PNP 2014-021

SUBJECT: Response to Request for Additional Information dated February 26, 2014, for Relief Request Number RR 4-18 – Proposed Alternative, Use of Alternate ASME Code Case N-770-1 Baseline Examination

Palisades Nuclear Plant  
Docket 50-255  
License No. DPR-20

### Response to Request for Additional Information for Relief Request Number RR 4-18 – Proposed Alternative, Use of Alternate ASME Code Case N-770-1 Baseline Examination

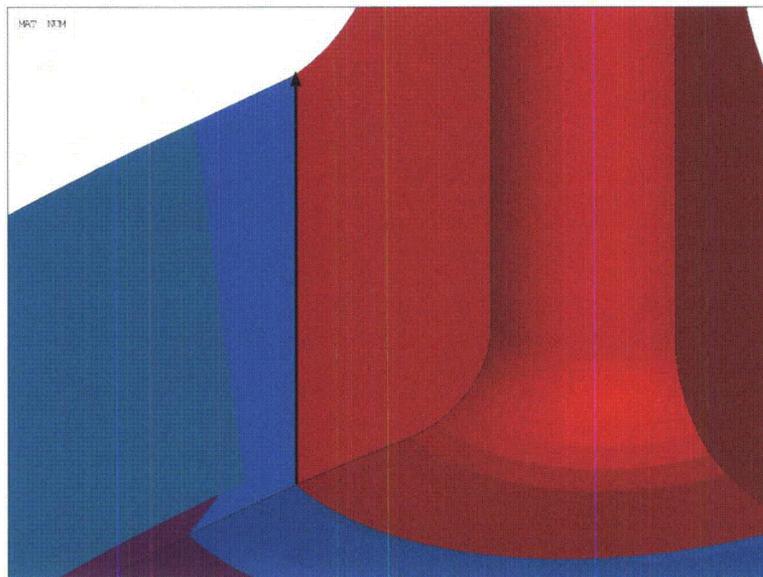
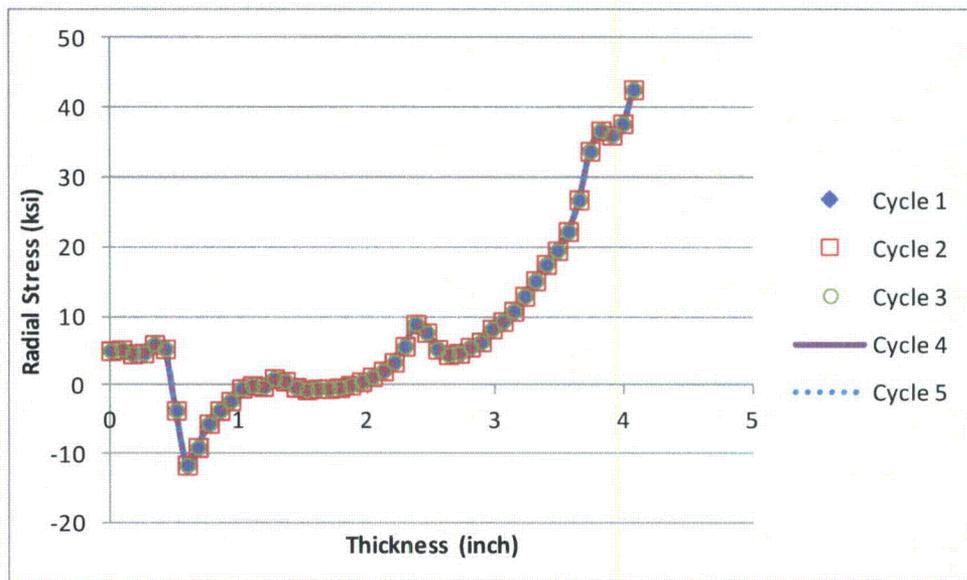
*What was the basis for the 5-cycle shakedown – typically it is not included in weld residual stress calculations?*

- a. *Why was 5 cycles used versus two or three cycles for example?*
- b. *How was each shakedown modeled?*
- c. *What is the effect of the shakedowns as they were applied? (i.e. provide weld residual stresses for each application of the technique.)*

Operational cycles are frequently included in welding residual stress calculations as a part of determining the operating stress condition. In particular, the standard modeling practice adopted by the xLPR (Extremely Low Probability of Rupture) welding residual stress team, which includes the NRC, national laboratory, and industry participants, specifies that the welded configuration should be cycled between operating conditions and residual conditions to shake down the nonlinear material hardening behavior. Typically, three to five cycles are used to shake down the material's behavior.

- a. Since the primary interest from the residual stress analysis is to provide residual stresses for calculating stress corrosion crack growth under normal operating conditions, it is desirable to determine a stabilized residual stress state that will not change under normal operating cycles. The as-welded residual stresses usually contain localized peak stresses

at some nodal locations. Applying a few operating cycles will stabilize the stress peaks and valleys due to the slight stress redistribution at elevated temperatures. It has been determined through experience that the residual stresses will stabilize after three to five cycles. Five cycles was used for conservatism.

- b. The modeling of the operating cycles involved simultaneously ramping the operating temperature and pressure between the no load and full load conditions repeatedly five times. Residual stresses at the fifth operating cycle were extracted for the crack growth calculation.
- c. An example through-wall stress path at the weld/nozzle interface at the 90-degree azimuth is used to investigate the residual stresses at each operating cycle. The results show that the residual stresses are stabilized because there is virtually no change in the profiles among the five cycles. This is primarily due to the resulting stresses developed in the fabrication process.

The details of the nozzle are shown on Palisades Drawing M-1D-0108. The hot leg drain nozzle is shown as part number 675-03 as shown below.

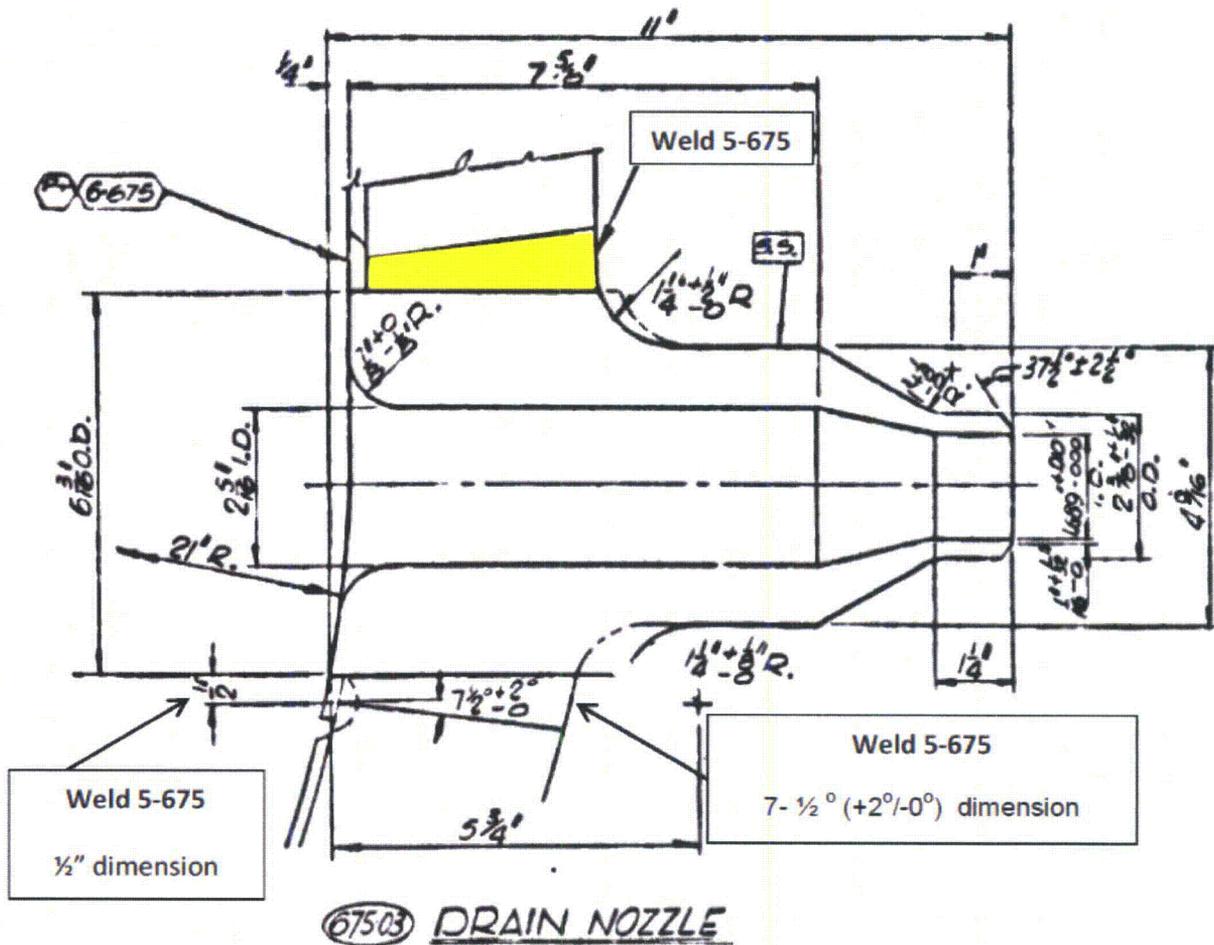
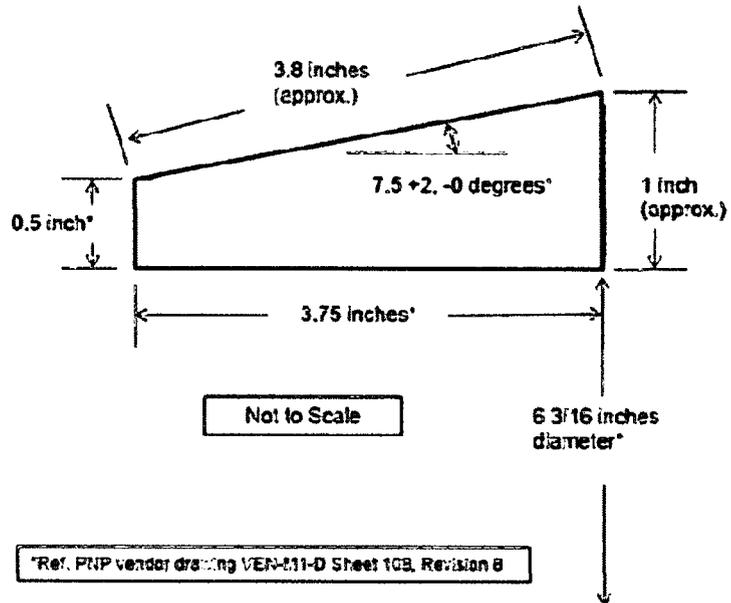
*Provide detailed geometry information of the weld, including weld thickness.*

The weld is ½ inch wide at the ID of the hot leg pipe and then increases in width at a  $7\frac{1}{2}^{\circ}$  ( $+2^{\circ}/-0^{\circ}$ ) angle to the OD of the hot leg pipe. The thickness of the hot leg pipe is 3-¾ inches.

The weld number in question is designated as 5-675 on the drawing. The details show that it is 1/2 inch wide at the ID of the hotleg pipe and then increases in width at a 7- 1/2 ° (+2°/-0°) angle to the OD of the hot leg pipe.

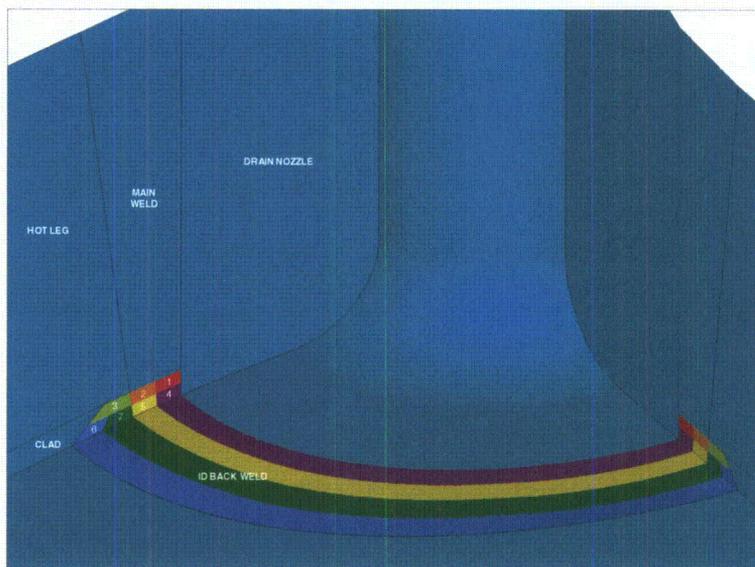
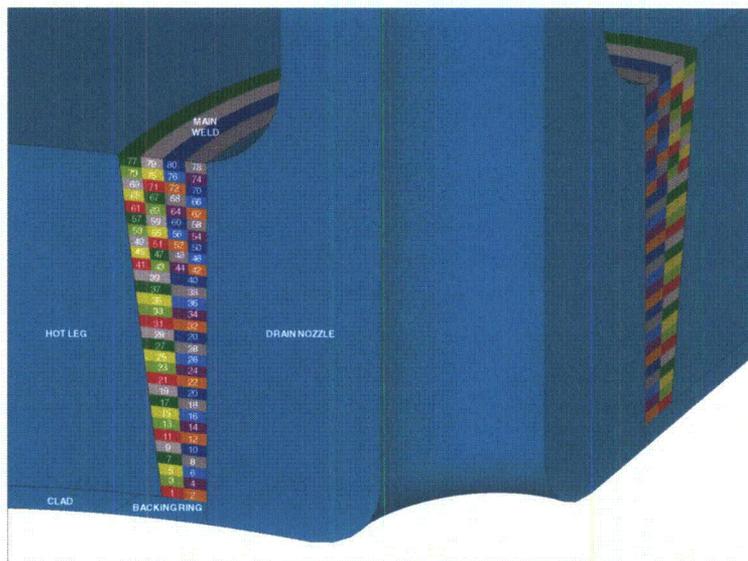
*Provide weld bead application sequence.*

The weld beads were modeled as full bead rings, with 80 bead rings defined for the main weld, and seven bead rings defined for the inside diameter patch weld per the labeled sequence shown in the figures below.

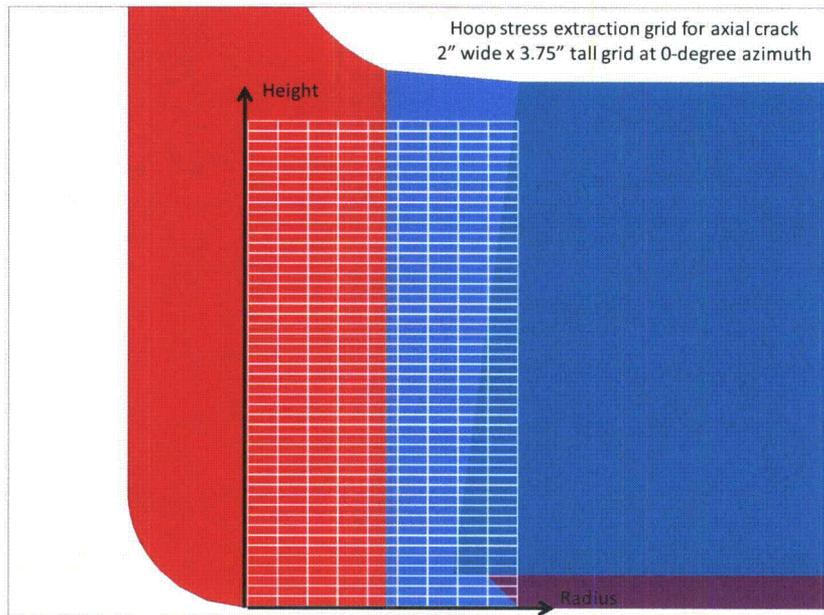
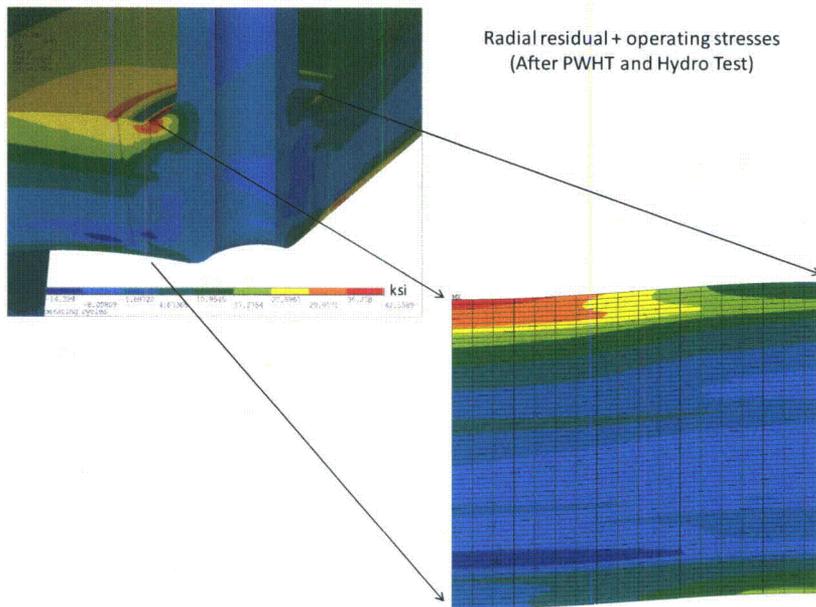
*Provide weld parameters chosen in model.*

The welding parameters used in the ANSYS finite element analyses are as follows:

Interpass temperature	=	350°F
Melting temperature	=	2500°F
Ambient temperature	=	70°F
Heat input both welds	=	28 kJ/in
Heat efficiency both welds	=	0.8
Inside/Outside heat transfer coefficient	=	5 Btu/hr/ft <sup>2</sup>
Inside/Outside temperature	=	70°F

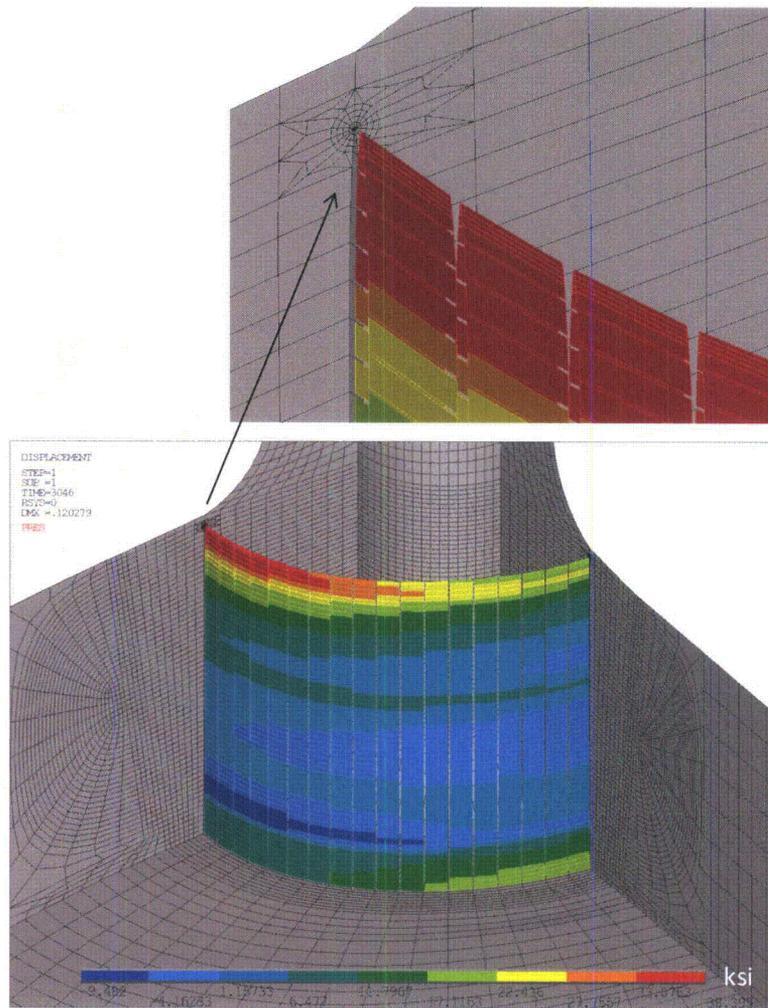
*Was the WRS profile fit with a polynomial? If so, what order was the polynomial? If not, how were K values derived?*

For the circumferential crack, the stress intensity factors, including the residual stresses, were calculated via deterministic finite element analyses using linear elastic fracture mechanics (LEFM) principles. Seven fracture mechanics finite element models are derived to include “collapsed” crack meshing that represent full circumferential flaws surrounding the nozzle at various depths within the boss weld. The depths vary from 0.13 inch to 3.95 inch.

High order SOLID95 elements in ANSYS were used around the crack tips, with the mid-side nodes shifted to the “quarter point” locations to properly capture the singularities at the crack tips. The 3.95 inches deep crack is shown as an example.

In order to determine the “Ks,” the radial component (relative to the nozzle) residual stresses, plus operating stresses at the boss weld/nozzle interface, were extracted from the residual stress analysis and reapplied on the crack face as surface pressure loading. The transferred radial stresses onto the crack face are also shown in the figure below.
